Crystal River Nuclear Plant
Docket No. 50-302
Operating License No. DPR-72

August 18, 2011
3F0811-01

Subject: Crystal River Unit 3 – Response to Request for Additional Information to Support NRC Instrumentation and Controls Branch Acceptance Review of the CR-3 Extended Power Uprate LAR (TAC No. ME6527)

**RESPONSE TO REQUEST FOR ADDITIONAL INFORMATION
TO SUPPORT NRC INSTRUMENTATION AND CONTROLS
BRANCH ACCEPTANCE REVIEW OF THE CR-3 EPU LAR**

Figure 3.3.19-1 (page 1 of 1)
Loss of Subcooling Margin Allowable Value

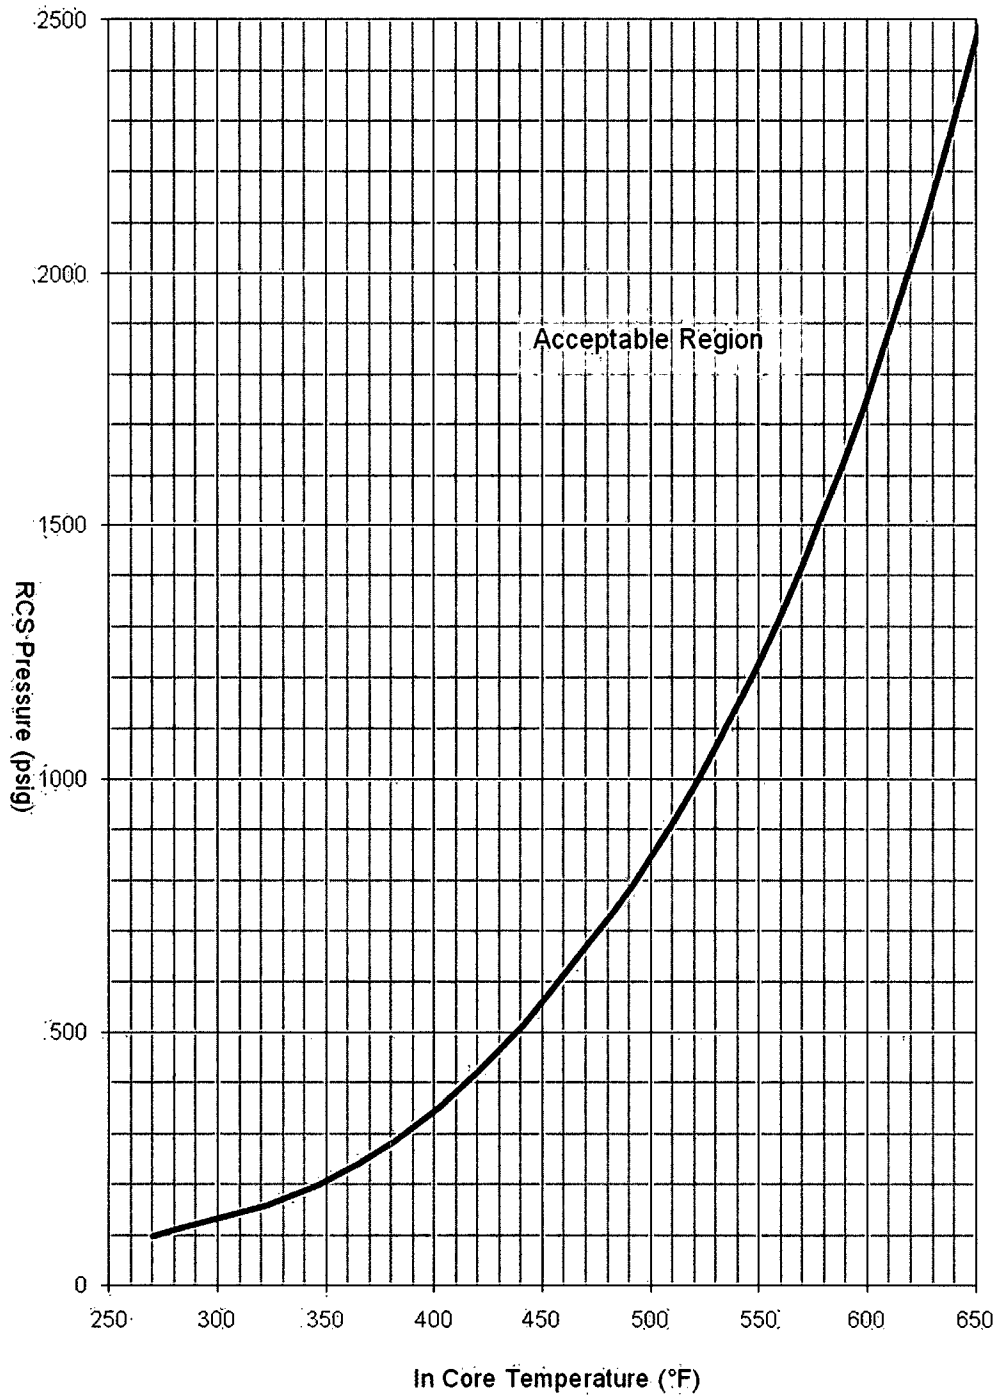
1. LAR Attachment 2, Table 3.3.19-1, "Inadequate Core Cooling Monitoring System (ICCMS) Instrumentation" (Pages 3.3-48 and 3.3.49) and Table 3.3.20-1, "Inadequate Core Cooling Monitoring System Automatic Actuation Logic" do not list Allowable Values or Limiting Trip Setpoints. Provide Allowable values and/or Limiting Trip Setpoints for each FUNCTION in these two Tables, or provide your justification for not listing these values.

The only ICCMS instrument functions listed in Improved Technical Specifications (ITS) Table 3.3.19-1 that provide an initiation channel trip are Loss of Subcooling Margin Function (Functions 1.e, 2.d, and 3.d) and Inadequate HPI Flow Function (Function 1.f). All other instrument functions listed in ITS Table 3.3.19-1 are instrument inputs to either the Loss of Subcooling Margin Function or the Inadequate HPI Flow Function and have no trip settings. Additionally, the trip setting values associated with the Loss of Subcooling Margin and Inadequate HPI Flow Functions are a function of generated curves and thus do not have discrete instrument Allowable Values analogous to the RCS Variable Low Pressure Allowable Value in the Reactor Protection System Technical Specification (Reference 2). As a result, an Allowable Value column is not included in ITS Table 3.3.19-1.

Enclosure 1 provides changes to the new ICCMS instrumentation Technical Specification and associated Bases proposed in the CR-3 EPU LAR (Reference 1). SR 3.3.19.3 is modified and two new figures are added to indicate the Allowable Values associated with the Loss of Subcooling Margin and Inadequate HPI Flow Functions. Enclosure 1 includes a markup of the affected ITS 3.3.19 pages and affected Bases pages of ITS B 3.3.19.

- a. Loss of Subcooling Margin Function: within the Acceptable Region specified in Figure 3.3.19-1; and
- b. Inadequate HPI Flow Function: within the Acceptable Region specified in Figure 3.3.19-2.

The Loss of Subcooling Margin Allowable Value is specified in Figure 3.3.19-1 and was selected to be conservative enough to detect a loss of subcooling margin thus ensuring the reactor coolant pumps trip will before reaching two phase conditions within the RCS during LOCAs with loss of offsite power available. The Allowable Value includes severe environment induced errors because ICCMS input sensors and associated instrumentation (e.g., RCS pressure sensors and transmitters) must function in a harsh environment as defined in 10 CFR 50.49 (Ref. 4).

1.1 Instrument Loops

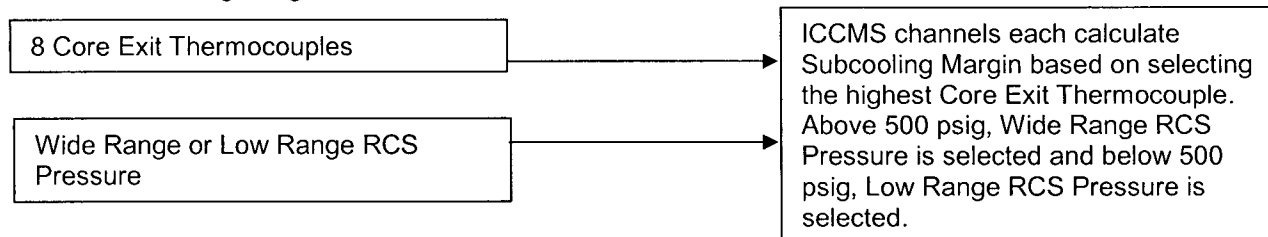
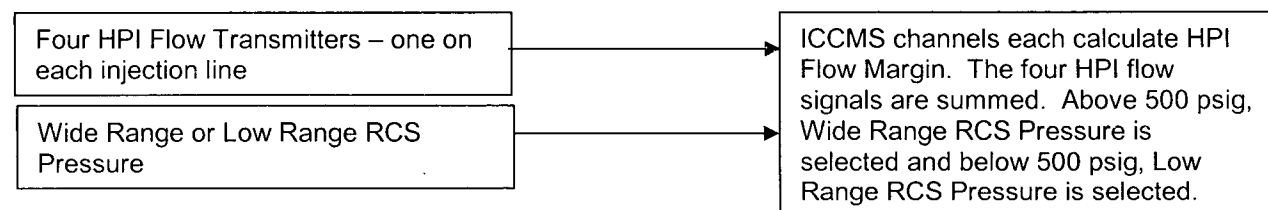
4. Provide instrument loop schematic diagrams and control logic diagrams including sufficient information to show the input, output parameter signal logic flow, and bistable devices which implement the setpoints for each FUNCTION of ICCMS to support the safety evaluation.

The following are simplified block diagrams of the ICCMS instrument loops indicating the input parameters associated with the Loss of Subcooling Margin and Inadequate HPI Flow Functions.

Figure 3.2-2

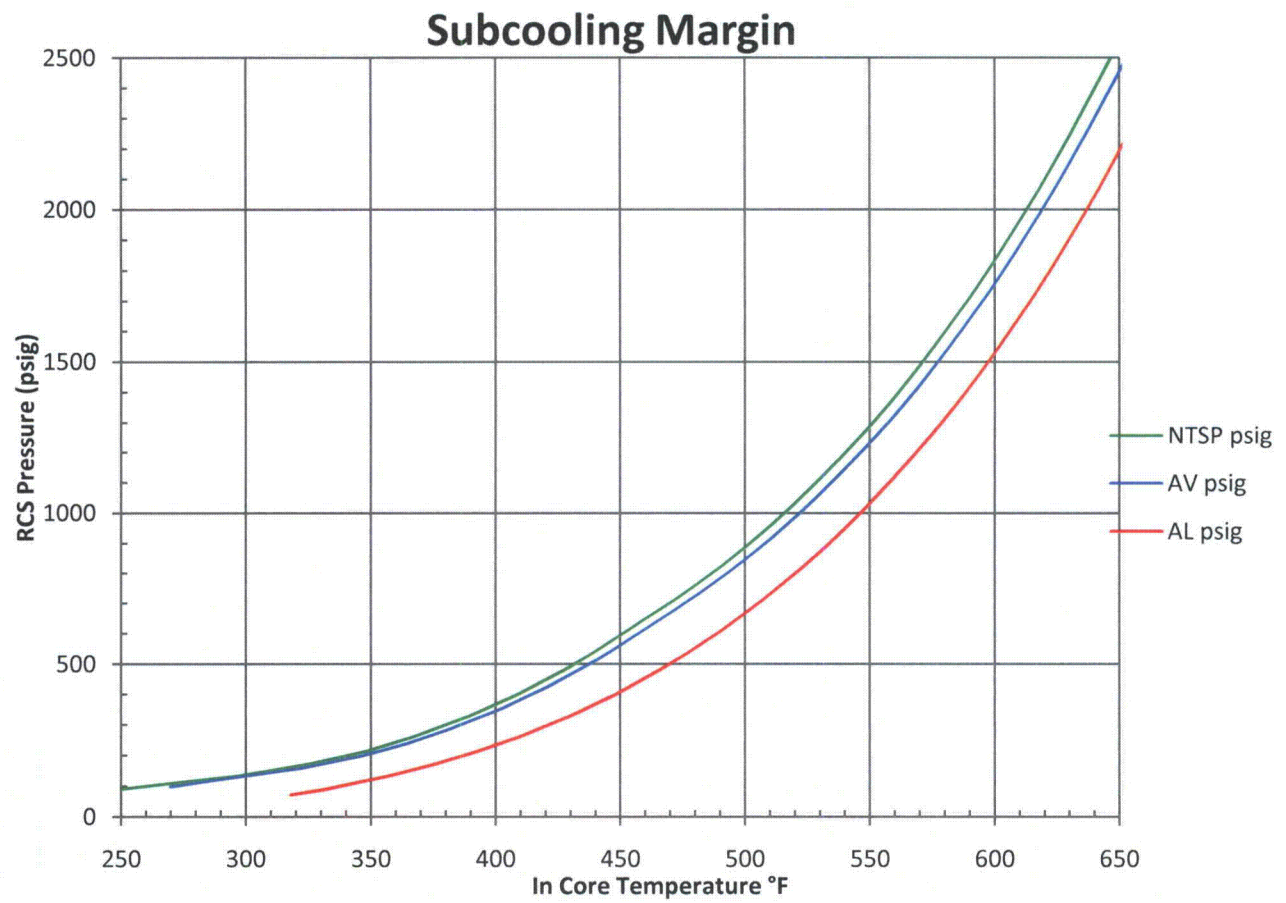
2. TSTF-493, Option A "with changes to setpoint values" requires the licensee to provide summary calculations for each type of setpoint being revised, including Limiting Trip Setpoint (LTSP), Nominal Trip Setpoint (NTSP), Allowable Value (AV), As-Found Tolerance (AFT), and As-Left Tolerance (ALT). Provide all these values and analytical safety limit value for each revised setpoint listed in Table 3.3.19-1, and Table 3.3.20-1 (the NRC staff prefers a table of values of all above variables for each LSSS setpoint). Also describe how these values were determined including examples and/or diagrams to support the determination.

Figure 3.2-2 presents a graphical representation of the AL, AV and NTSP based on Table 3.2-3. The margin between the AV and the NTSP is the AFT and this margin increases as the pressure and temperature decrease.
